7.4 NoR 4: SH1 Improvements - Urban Design Matters

Table 7: Urban Design Evaluation for NoR 4 – SH 1 Improvements

7.4.1 NoR 4: SH1 Improvements Outcomes and Opportunities Maps

OUTCOMES AND OPPORTUNITIES PLAN - SHEET 1 OF 4

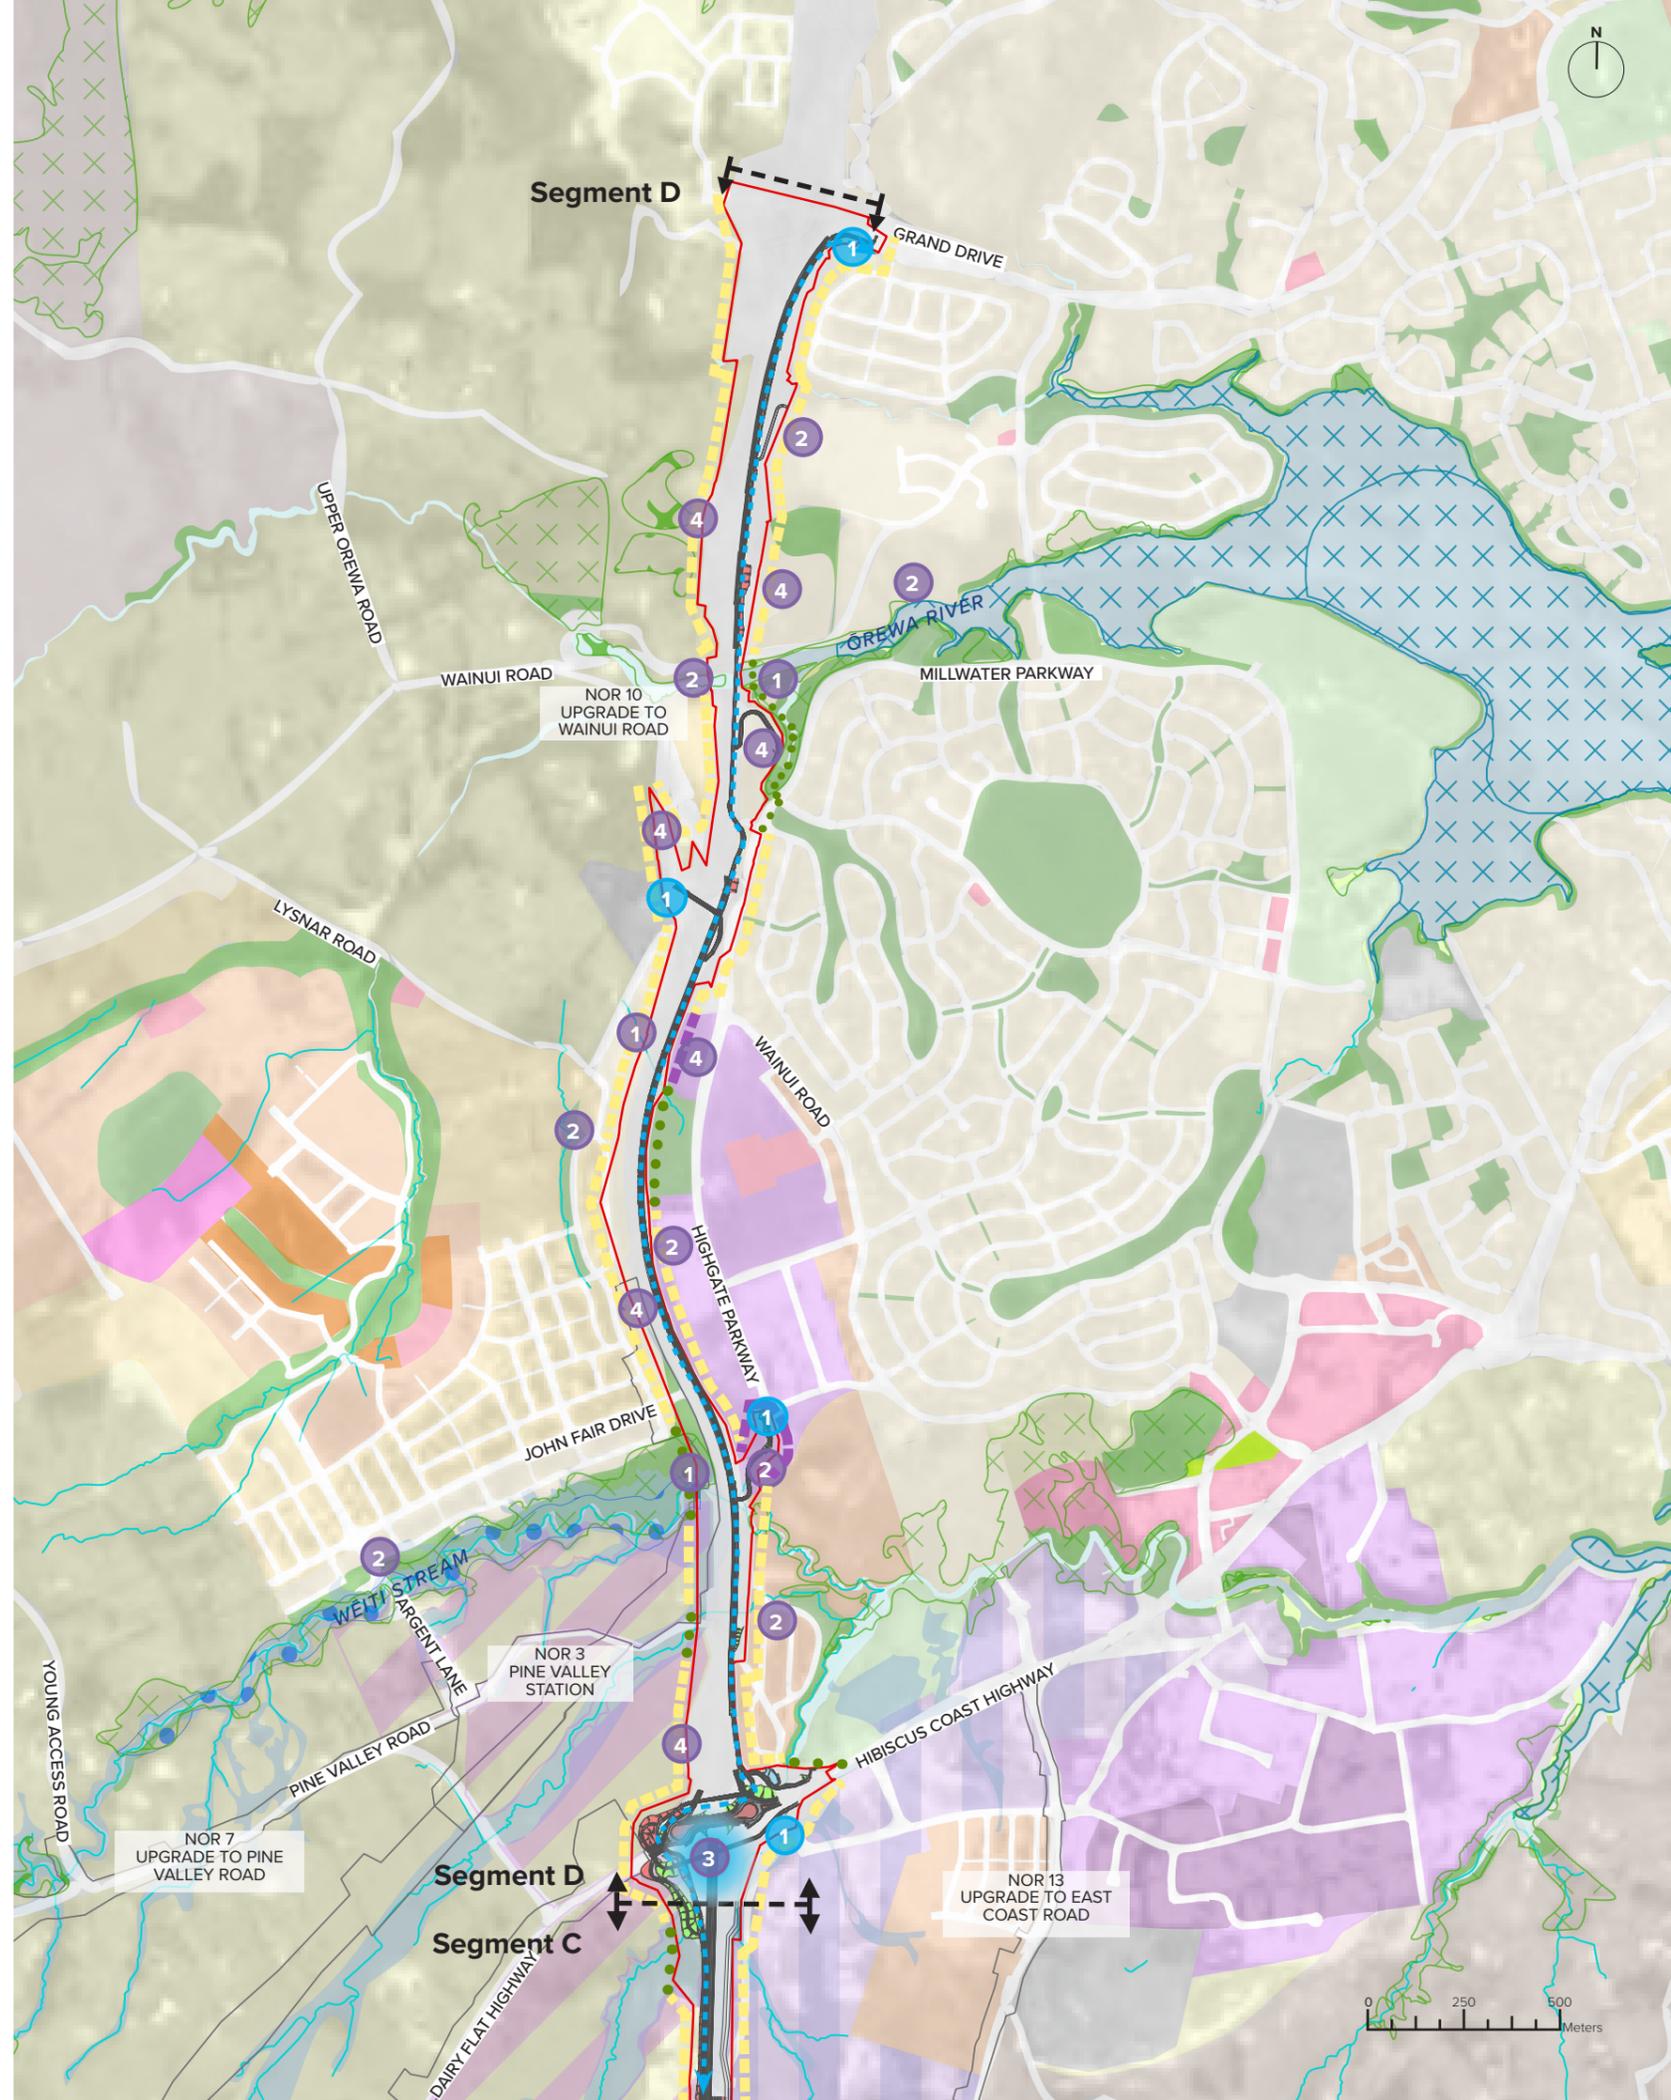
- 1 **Ecological connectivity** - Landscape outcomes should reinforce the wider vegetation patterns of the local open spaces and support ecological connectivity and biodiversity where the corridor crosses Wēiti Stream and Ōrewa River.

- 2 **Identity drivers** - Key local community, landscape character and identity drivers should be identified, developed and integrated with the adjacent land use functions and future design response, including future land use and centres, existing development in Milldale, Millwater and Ōrewa, and adjacent Wēiti Stream and Ōrewa River.

- 3 **Active mode legibility and priority** - Legibility, connectivity demands, safety and modal priority for active modes should be addressed at intersections.

- 4 **Earthworks** - Design earthworks at corridor boundaries to establish an appropriate interface with State Highway 1. Use retaining structures in areas where space is insufficient to deploy earthworks batters or where earthworks negatively impacts the efficiency of adjacent landuses. Where mass planting is proposed on batters, use native ecologically appropriate species.

- 1 **Gateway into urban areas** - The upgraded corridor will provide direct access into the existing Silverdale area, Milldale, Millwater and Ōrewa. The future design of the corridor, should consider the opportunity to provide a gateway into the area, assisting in way finding and defining the transition between land uses.

-  Establish an appropriate interface with the State Highway One corridor that manages the relationship between the corridor and adjacent land use and considers the amenity and safety of the active mode corridor.
-  Landscape outcomes that provides an appropriate interface to the blue and green network.
-  Intersection arrangement that addresses multi-modal priority, safety and legibility.

OUTCOMES AND OPPORTUNITIES PLAN - SHEET 2 OF 4

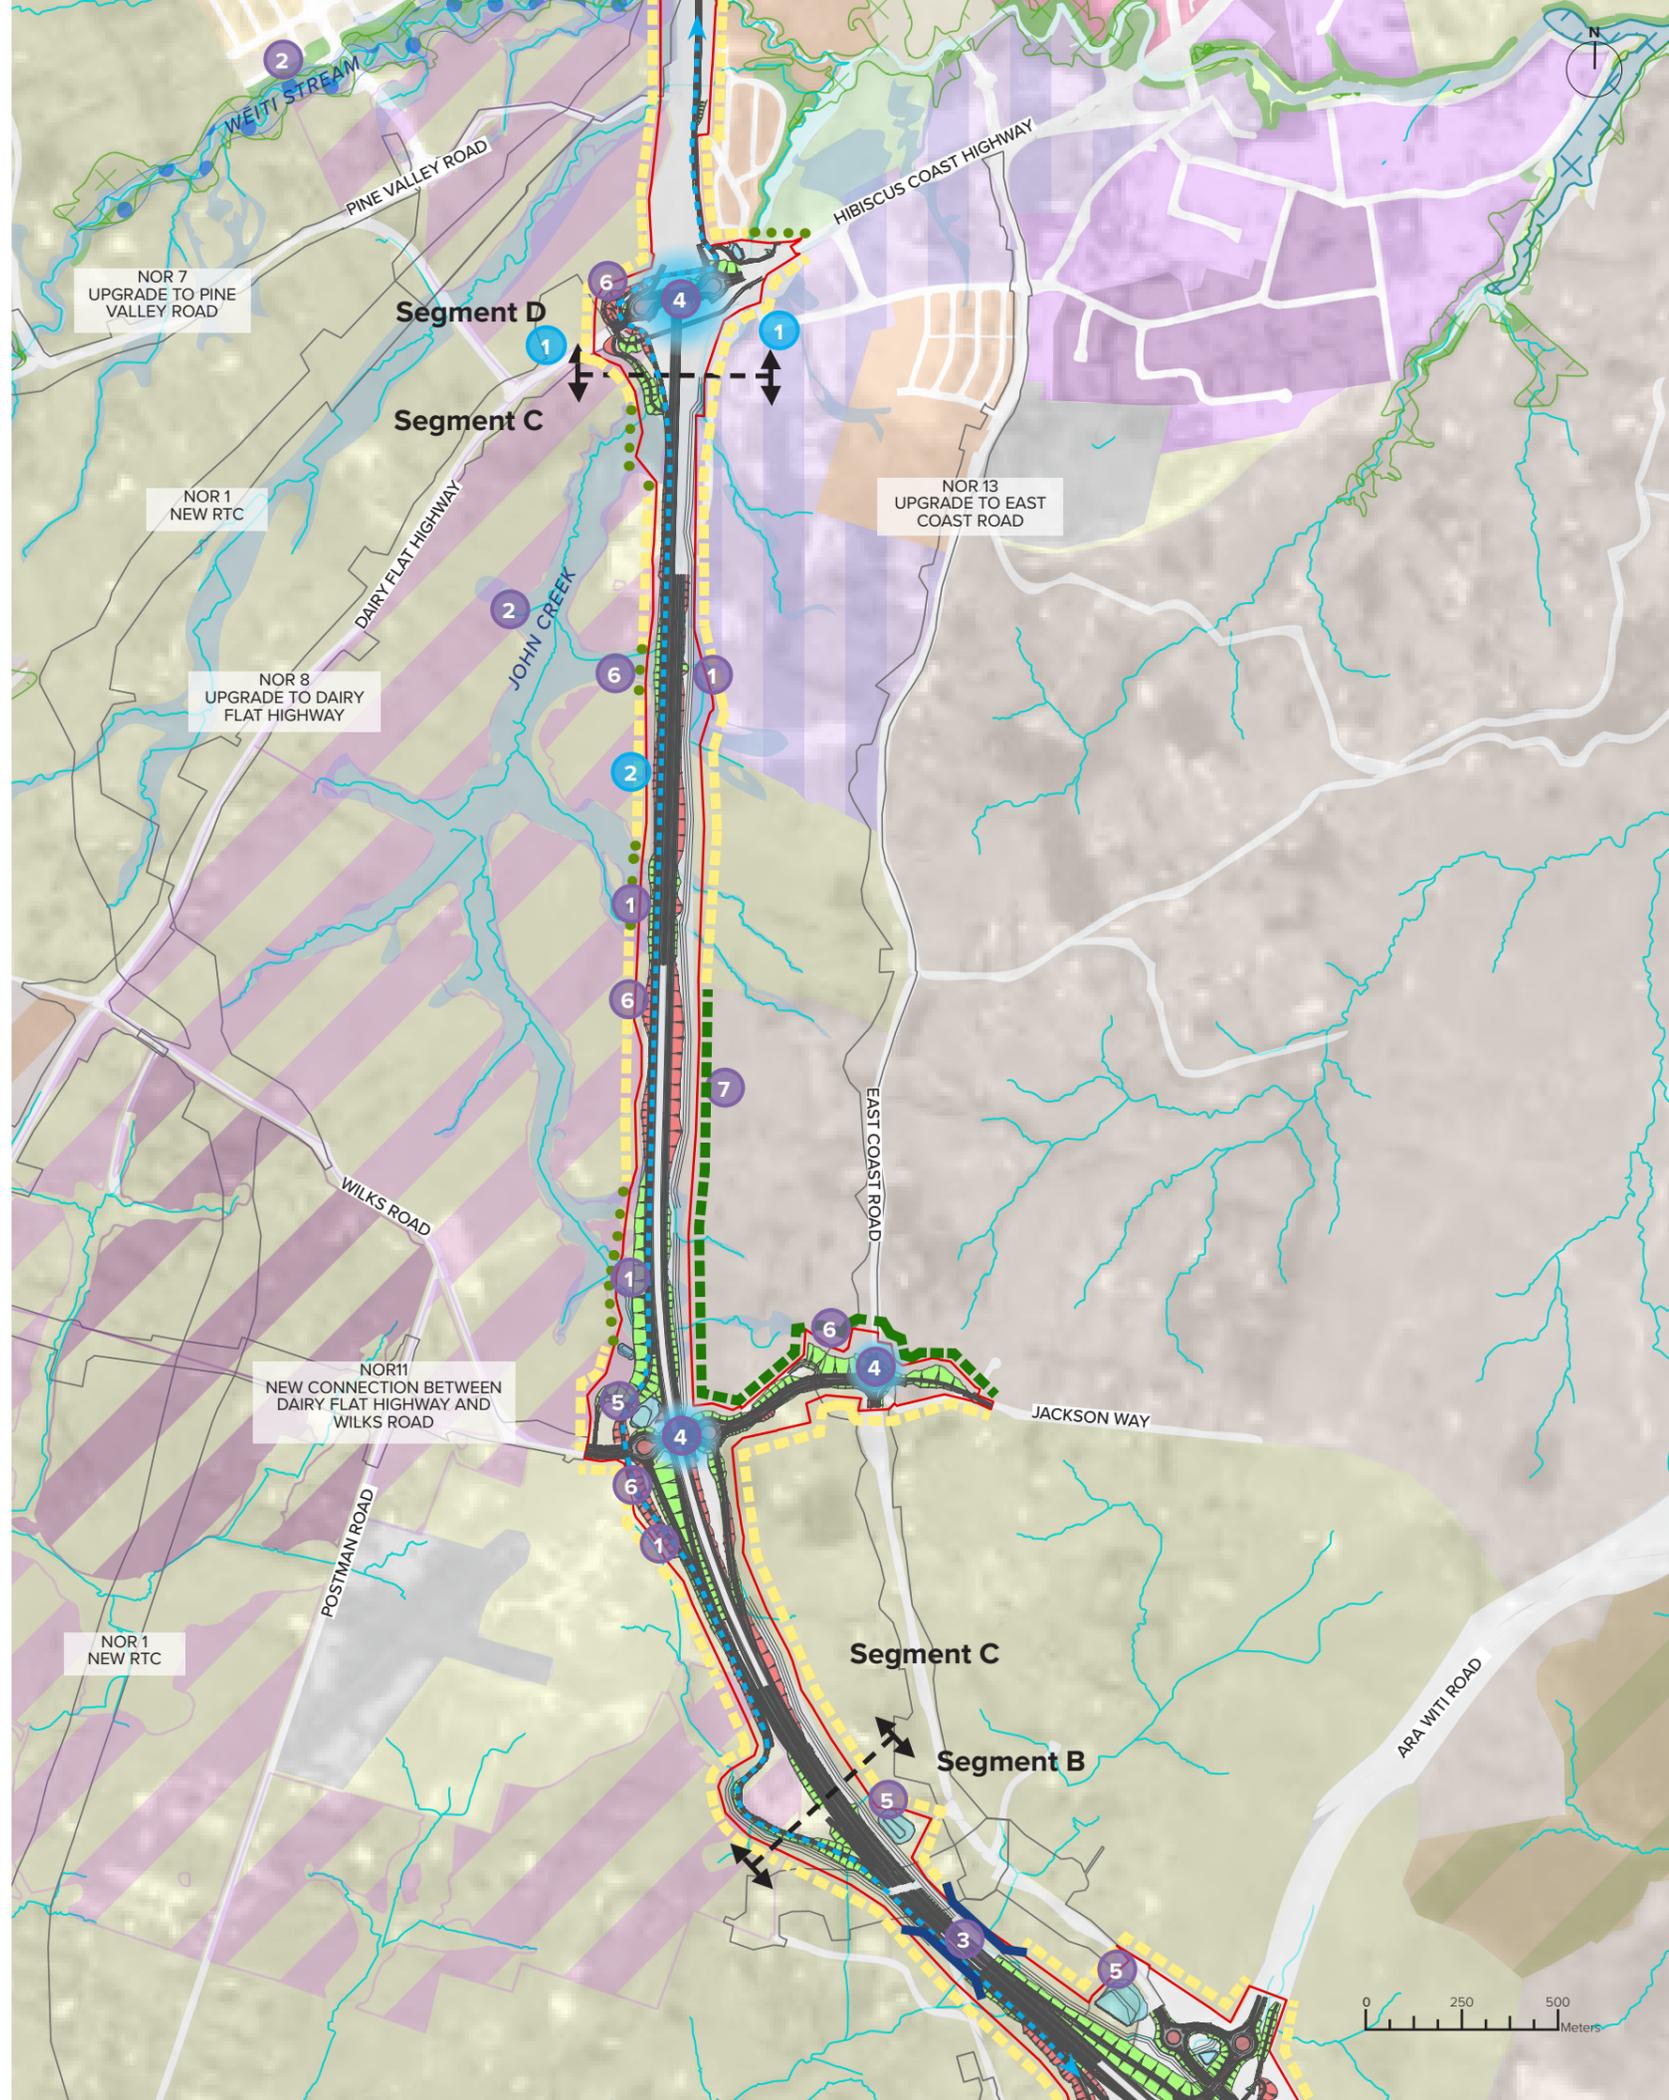
- 1 **Ecological connectivity** - Landscape outcomes should reinforce the wider vegetation patterns of the local open spaces and support ecological connectivity and biodiversity where the corridor crosses tributaries of John Creek.

- 2 **Identity drivers** - Key local community, landscape character and identity drivers should be identified, developed and integrated with the adjacent land use functions and future design response, including adjacent John Creek and its tributaries.

- 3 **CPTED** - Future design should incorporate CPTED principles including clear sightlines, good levels of lighting and passive surveillance, particularly at intersections and future cross-corridor connections. This should be a consideration of the active mode facilities which may have limited passive surveillance along the corridor from adjacent land use.

- 4 **Active mode legibility and priority** - Legibility, connectivity demands, safety and modal priority for active modes should be addressed at intersections.

- 5 **Stormwater Wetlands** - Consider integration outcomes for wetland/s such as setbacks, arrangement and scale of planting to support an appropriate interface to the road corridor, adjacent land use and development.

- 6 **Earthworks** - Design earthworks at corridor boundaries to establish an appropriate interface with State Highway 1. Use retaining structures in areas where space is insufficient to deploy earthworks batters or where earthworks negatively impacts the efficiency of adjacent landuses. Where mass planting is proposed on batters, use native ecologically appropriate species.

- 7 **Integration of earthworks with the rural zone** - Future earthworks design that interfaces with the rural zone should consider how these can be shaped and landscaped to integrate into the rural character of the rural zone.

- 1 **Gateway into Silverdale Area** - The corridor will provide direct access into the existing Silverdale area, and the future Silverdale West Industrial Area. The future design of the upgrade corridor should consider the opportunity to provide a gateway into the area, assisting in way finding and defining the transition between land uses.

- 2 **Cycleway connections** - Maximise cycleway connections along corridor into the future local network.

- Establish an appropriate interface with the State Highway One corridor that manages the relationship between the corridor and adjacent land use and considers the amenity and safety of the active mode corridor.
- Establish an interface that responds to the adjacent rural zone, integrating the corridor into the adjacent land form and include appropriate planting and screening.
- Establish landscape outcomes that provides an appropriate interface to the blue and green network.
- Consideration of visual integration, interface and sense of place for the bridge structure.
- Intersection arrangement that addresses multi-modal priority, safety and legibility.
